Work Order ID 96597

Item Name: 205 Bent Tube

DRAWING NO. D2580	TITLE 205 SKIDTUBE ASSEMBLY	REV. E	DART AEROSPACE LTD ENGINEERING ORDER		D.E.O. NO. D2580-E-1	SHEET NO. SHEET 1 OF 1	SCALE NTS
DRAWN UP	CHECKED ASS	MFG. APPR. ER	APPROVED #		DE APPR. #		
DATE 11.12.13	DATE 11.12.13	DATE 11.12.13	DATE 11.12.13		DATE 11.12.13

CHANGE ALL C'BORED WELDED CROSSBOLT SPACERS TO SWAGED SPACERS

SECTION B-B, F-F, I-I
NOT TO SCALE

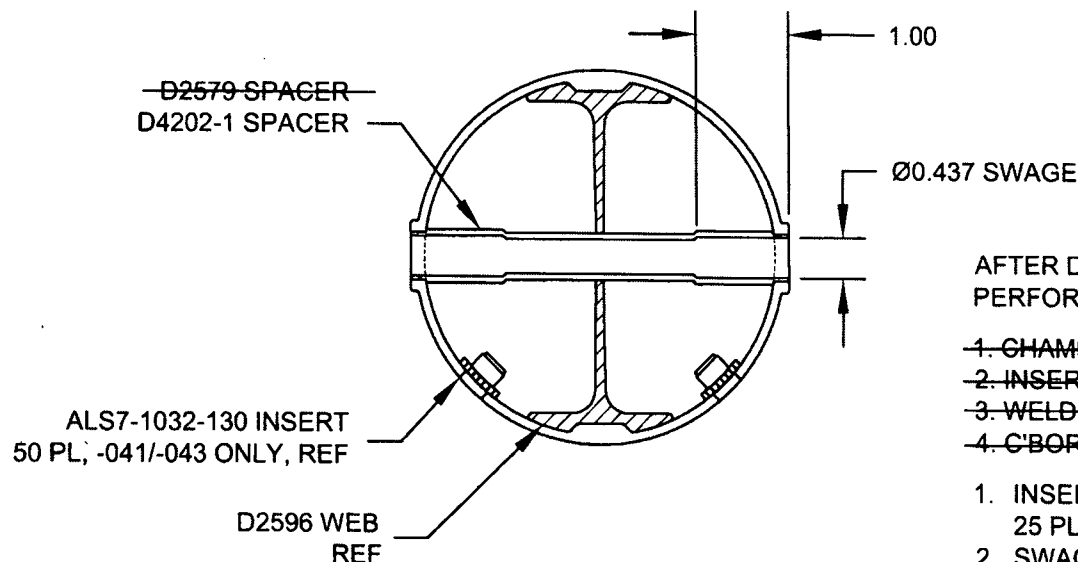
SECTION B-B, SECTION F-F, & SECTION I-I ARE AMENDED AS FOLLOWS
FOR ALL HOLES THAT WERE ORIGINALLY C'BORED:

*** FOR -045 SKIDTUBE ONLY:**

WELD 4X D2579 SPACERS PER DWG
IN LOCATIONS MARKED "NO C'BORE".
REF SHEET 4 OF DWG.

AFTER DRILLING AND BENDING ASSEMBLY
PERFORM THE FOLLOWING FOR Ø0.508 HOLES ONLY:

1. CHAMFER HOLE 0.050 X 45°
2. INSERT D2579 SPACER (20 PLACES)
3. WELD INTO PLACE AND GRIND FLUSH
4. C'BORE D2579 SPACER TO Ø0.437 X 1.00 DEEP

4		* D2579	CROSS BOLT SPACER
20	20	25	D4202-1	SPACER

1. INSERT D4202-1 SPACER, 20 PL (-041) OR 20 PL (-045) OR 25 PL (-047)
2. SWAGE TO Ø0.437 X 1.00 DEEP PER QSI 002
3. TRIM / GRIND FLUSH PER QSI 002
